Proposal for the 05 series of amendments to Regulation No. 10 (Electromagnetic compatibility)

Moreover, the OICA experts have consolidated the proposals of documents WP.29/2013/73 and GRE-70-14 in the present document, which constitute the current proposal for the 05 series of amendments to Regulation No. 10 and which supersedes WP.29/2013/73.

Figure 1
HV artificial network

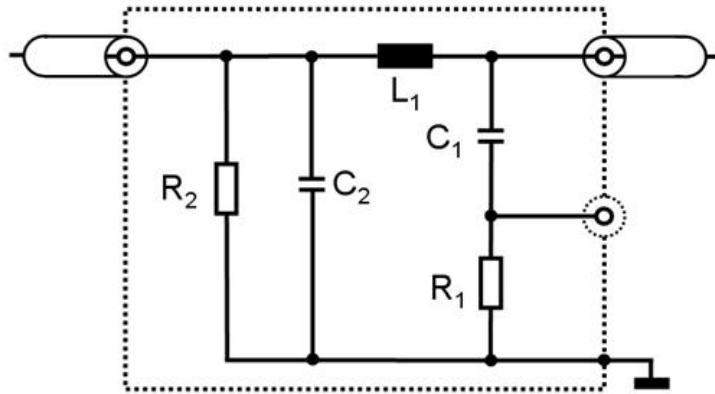
"Appendix 8

<i>Legend</i>	<i>C₂: 0.1 μF</i>
L₁: 5 μH	R₁: 1 kΩ
C₁: 0.1 μF	R₂: 1 MΩ (discharging C₂ to < 50 V_{dc} within 60 s)

Figure 1
Vehicle in configuration "REESS charging mode coupled to the power grid" – Single phase charger test set-up

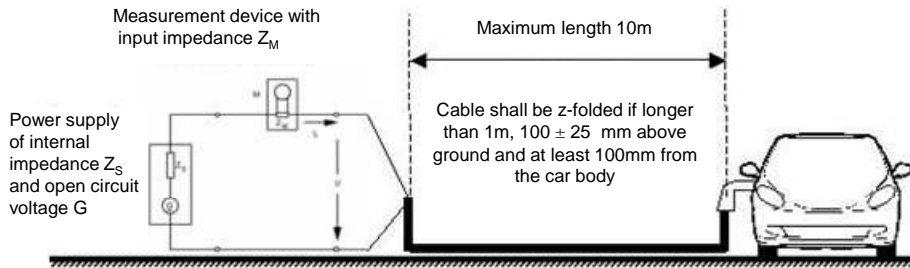
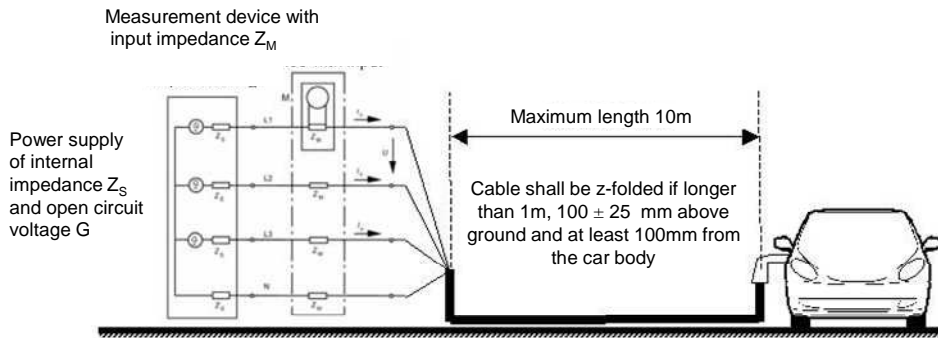
- 3.2. The test set-up for single phase vehicle in configuration "REESS charging mode coupled to the power grid" is shown in Figure 1 of the appendix to this annex.

- 3.3. The test set-up for three-phase vehicle in configuration "REESS charging mode coupled to the power grid" is shown in Figure 2 of the appendix to this annex.

Figure 1
Vehicle in configuration "REESS charging mode" coupled to the power grid coupling on AC/DC power lines

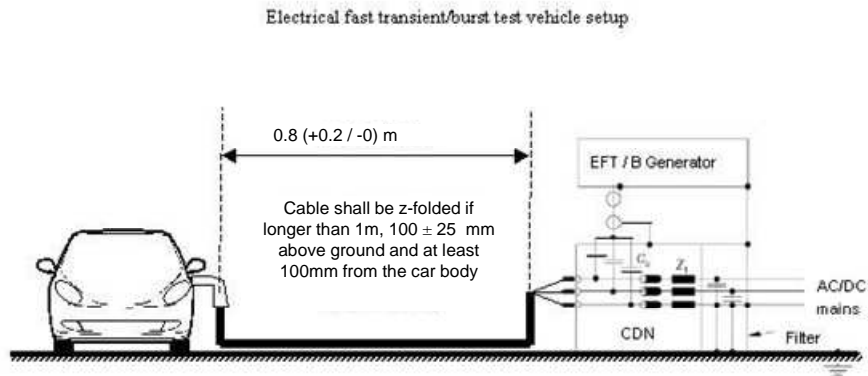
Annex 15, Appendix, amend to read:

The vehicle shall be positioned on the ground plane. The electrical fast transient/burst (EFT/B) shall be applied on the vehicle on the AC/DC power lines in common modes by using CDN as described in Figure 1 of the appendix to this annex.

Figure 1
Vehicle in configuration "REESS charging mode coupled to the power grid" –
Coupling between lines for DC or AC (single phase) power lines

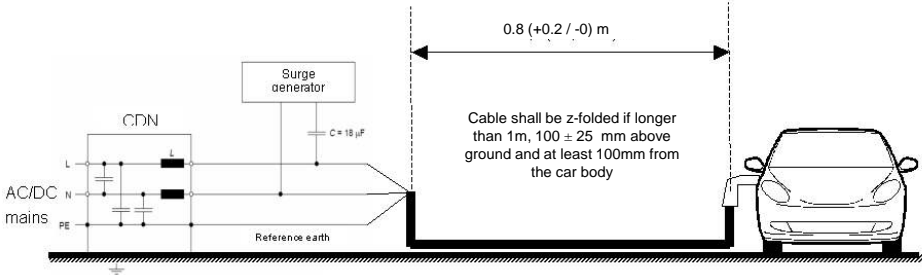
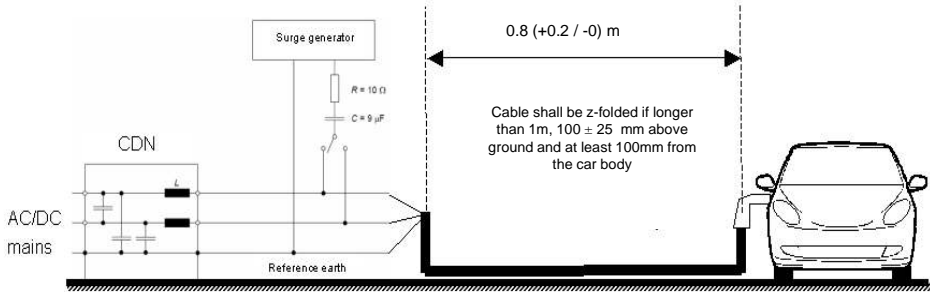
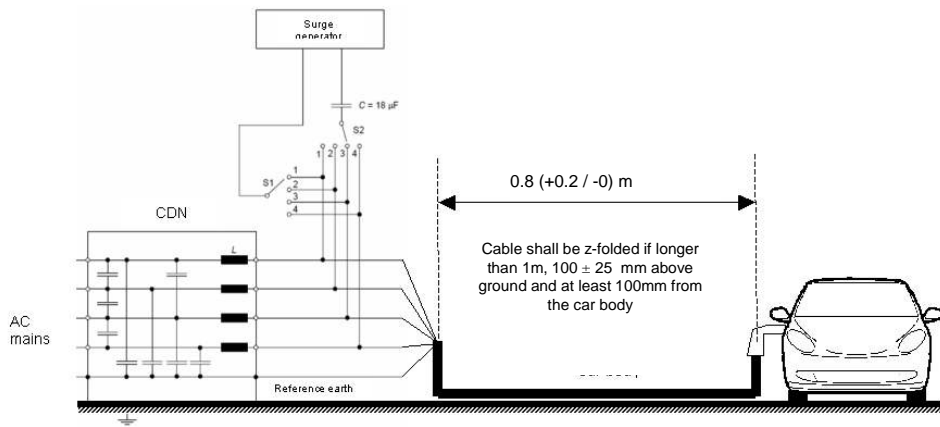
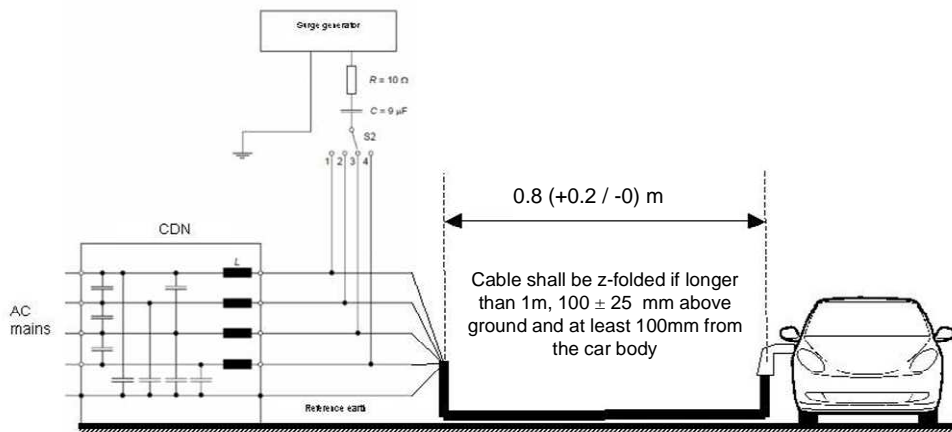
The vehicle shall be positioned on the ground plane. The electrical surge shall be applied on the vehicle on the AC/DC power lines between each line and earth and between lines by using CDN as described in Figures 1 to 4 of the appendix to this annex,

Figure 1
ESA in configuration "REESS charging mode coupled to the power grid" – Single phase test set-up

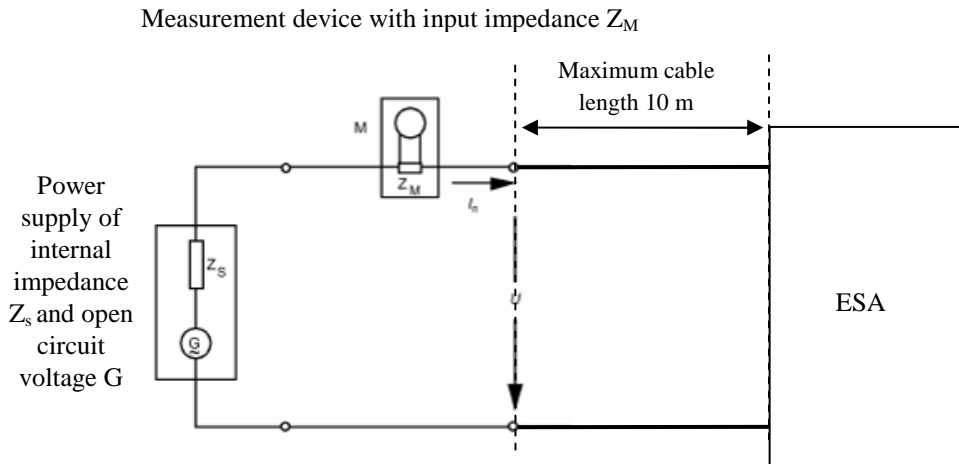
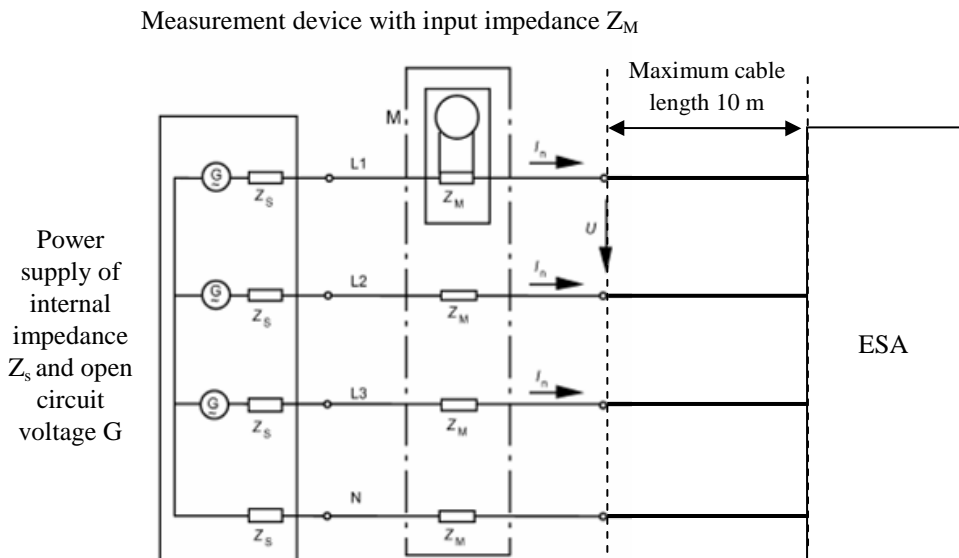
- 3.2. The test set-up for single phase ESA in configuration "REESS charging mode coupled to the power grid" is shown in Figure 1 of the appendix to this annex.

- 3.3. The test set-up for three-phase ESA in configuration "REESS charging mode coupled to the power grid" is shown in Figure 2 of the appendix to this annex.

Figure 1
ESA in configuration "REESS charging mode coupled to the power grid"

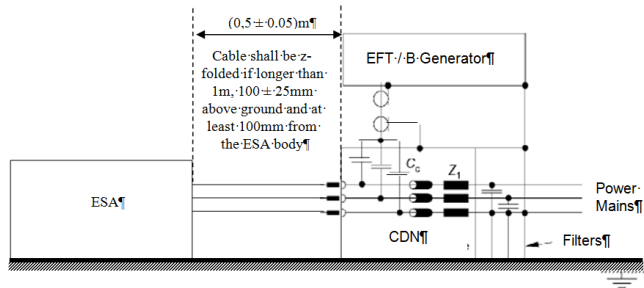
The ESA shall be positioned on the ground plane. The electrical fast transient/burst (EFT/B) shall be applied on the ESA on the AC/DC power lines in common modes by using CDN as described in Figure 1 of the appendix to this annex.
